NFPA 805 OBSERVATION VISIT TRIP REPORT

Location: Oconee Nuclear Station, Seneca, South Carolina

Subject: Risk-Informed, Performance-Based Fire Protection Transition Pilot-Plant Observation Visit - Oconee Nuclear Station

Figure 1. Multiple Spurious Post-Transition Inspections

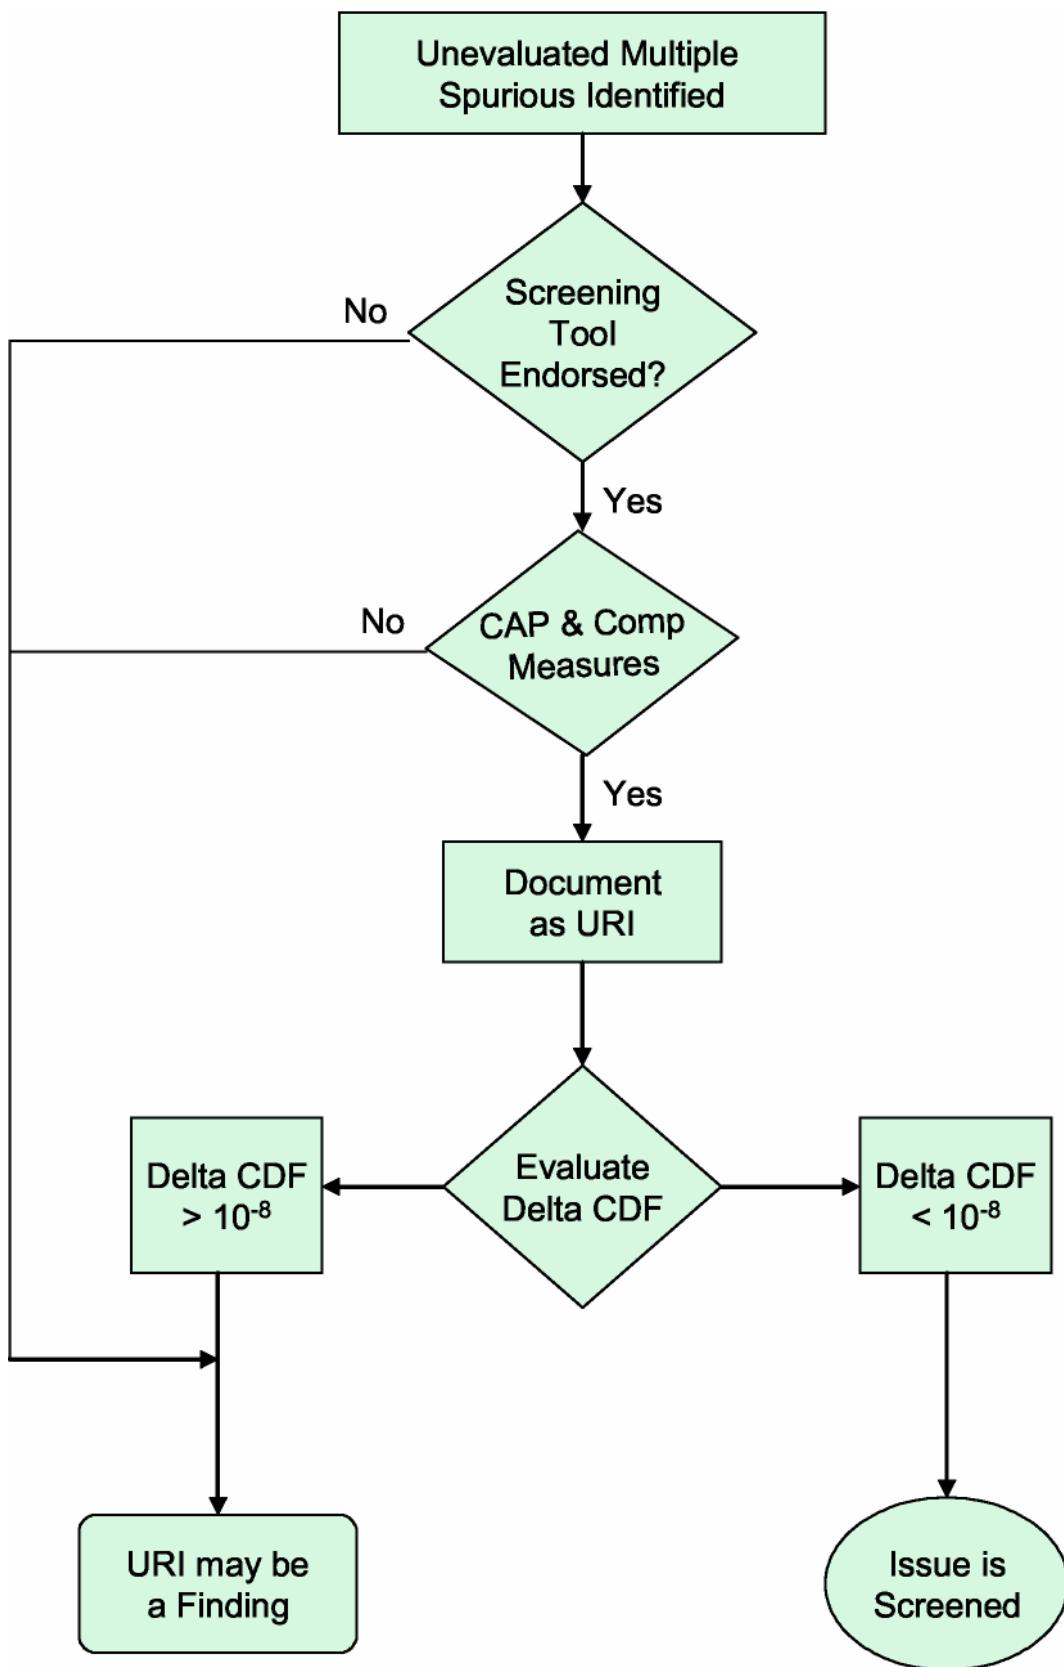
At the March 2006 pilot plant observation visit, the Staff presented a flow chart, illustrating how newly found multiple spurious circuits identified during an inspection, could be treated (See flow chart below). In addition to the flowchart, the following information was discussed:

- If circuits identified by an inspector and its related contributors were omitted, and their contribution to risk; are “greater than Green” OR “constitute a violation of defense-in-depth” or “safety margins,” in spite of using an appropriate screening tool, the issue would constitute a minor violation. If the inspector determines that the licensee’s screening tool is flawed, that would constitute a violation. Here “related contributors” are those that are associated via the same root cause, fire scenario, or fire area.

Resolution Action(s)/Action Party: OPEN. Industry and pilot-plant participants agreed to review the flowchart, IMC 0612 questions, screening thresholds and provide feedback to the NRC at the next observation visit. The industry may also submit an FAQ on the issue.
